Department of Energy

ADDITIONAL COMMENT RESPONSES FOR THE 303-K RADIOACTIVE MIXED-WASTE STORAGE FACILITY CLOSURE PLAN NOTICE OF DEFICIENCY RESPONSE TABLE

THE 303-K RADIOACTIVE MIXED-WASTE STORAGE FACILITY CLOSURE PLAN
NOD RESPONSE TABLE

Dates Indicate Year of Installation of Surface Material.

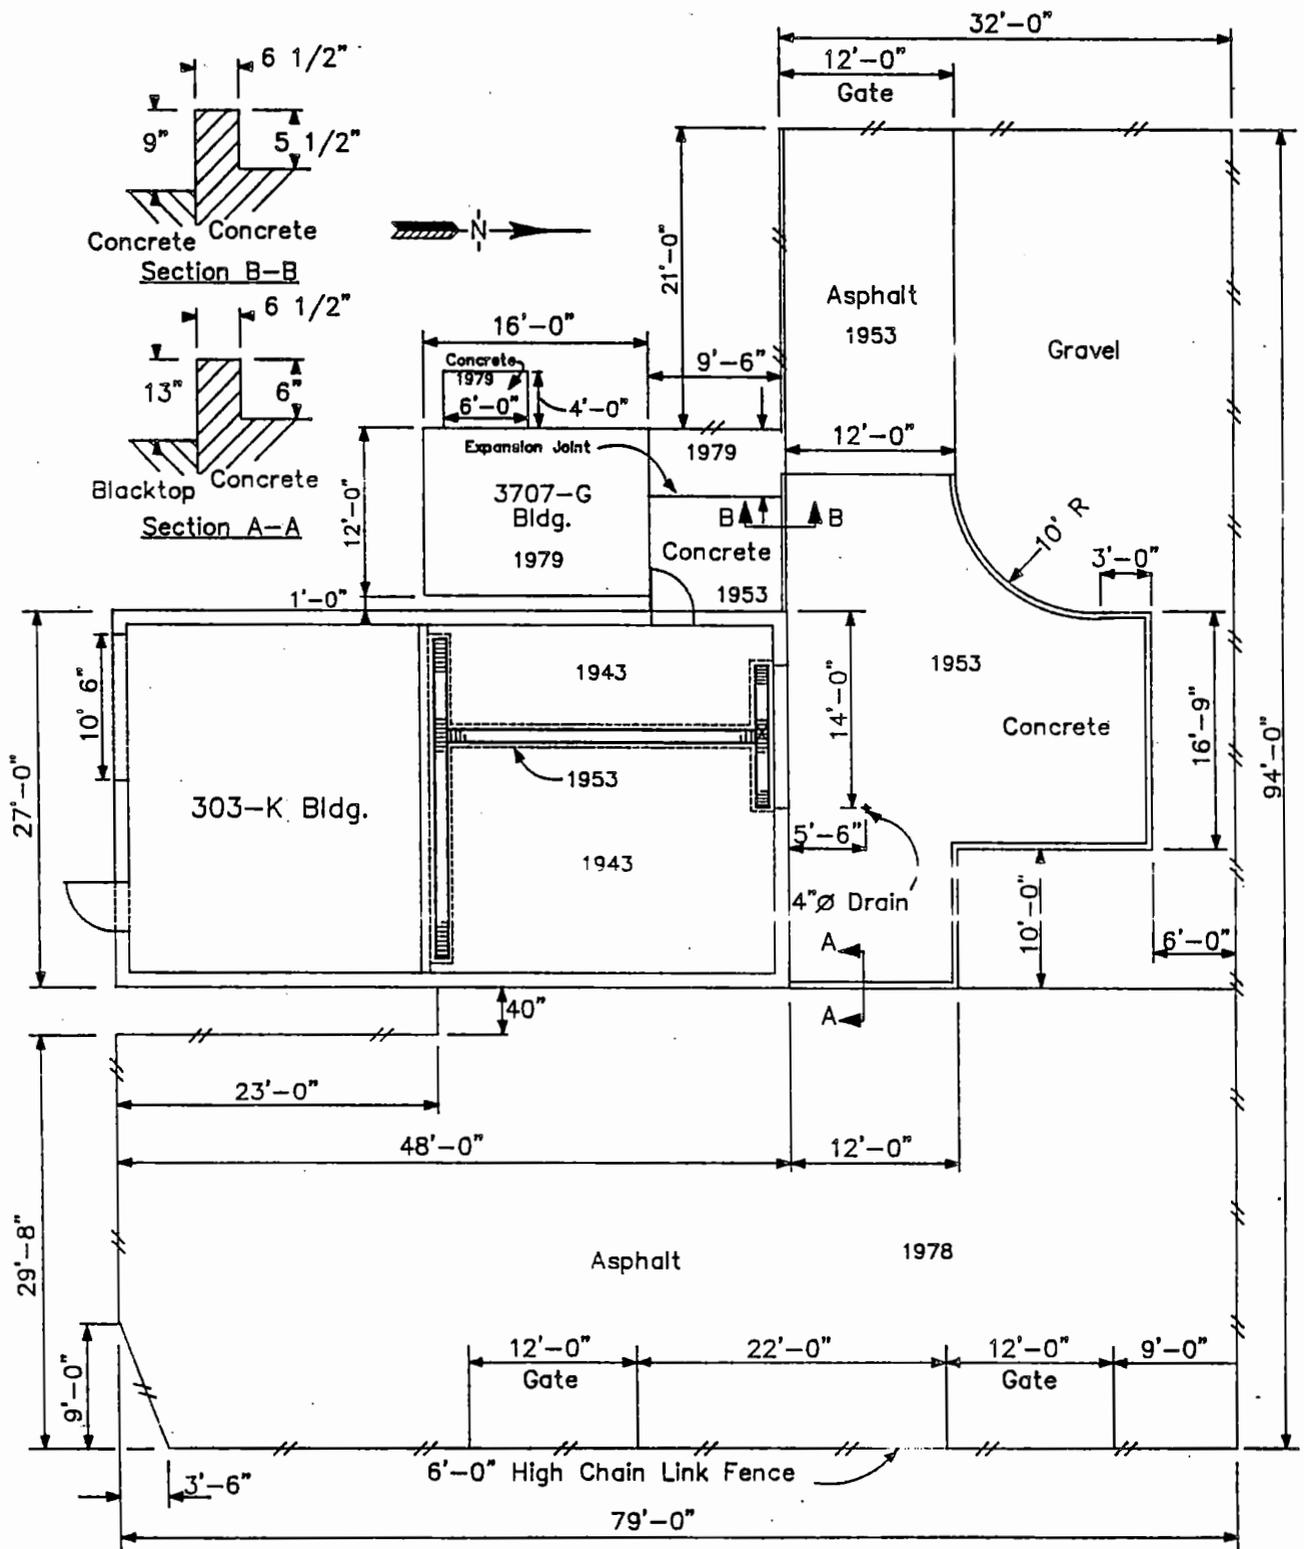
No.	Comment/Response
4.	<p>Page 2-1. The facility description is not clear as to the extent of modifications to the facility (i.e., dates when new asphalt was added, when additional lifts of concrete were added, etc.).</p> <p><u>Ecology Requirement:</u> A more detailed description of the facility must be provided.</p> <p>DOE-RL/WHC Response No. 1: The approximate dates for the various additional asphalt and concrete pads will be shown in a drawing.</p> <p>DOE-RL/WHC Response No. 2: The attached figure shows the dates when the various modifications to the 303-K Facility took place. This figure and additional text to introduce the figure will be added to the closure plan.</p>

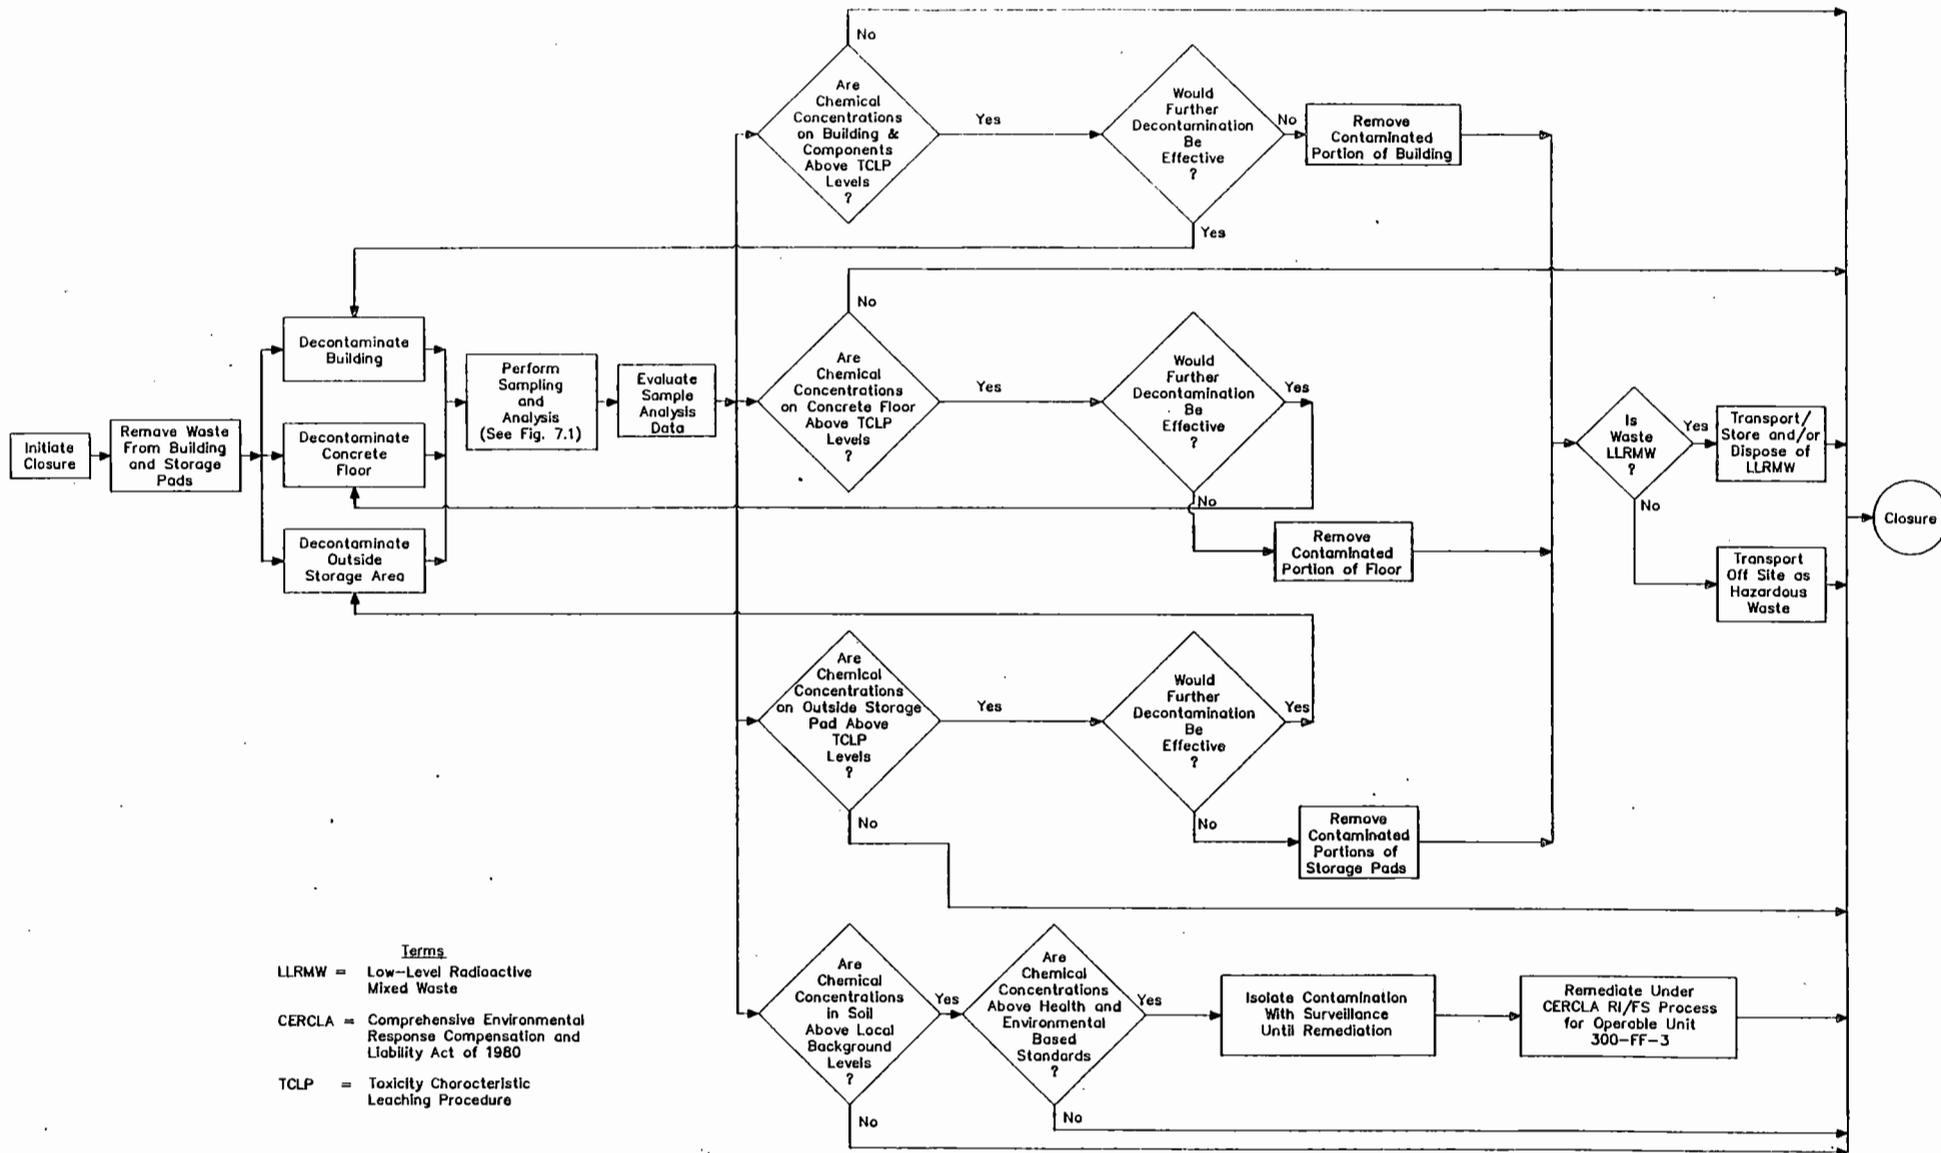
| 16. | <p data-bbox="172 358 1649 451"><u>Pages 6-3/6-4, Figure 6-1.</u> Although the logic behind this flow chart is appropriate, the performance standard associated with the decision points is not appropriate (refer to comment numbers 1 and 12).</p> <p data-bbox="172 483 1500 516"><u>Ecology Requirement:</u> Redo the flow chart to show the appropriate closure standards.</p> <p data-bbox="172 548 1553 613">DOE-RL/WHC Response No. 1: Another flow chart will be included to show general closure strategy. See response numbers 1, 12, and 14.</p> <p data-bbox="172 646 1596 678">DOE-RL/WHC Response No. 2: The flow chart in Figure 6-1 has been revised and is attached.</p> |

The attached flow chart shows the closure strategy for the 303-K Facility.
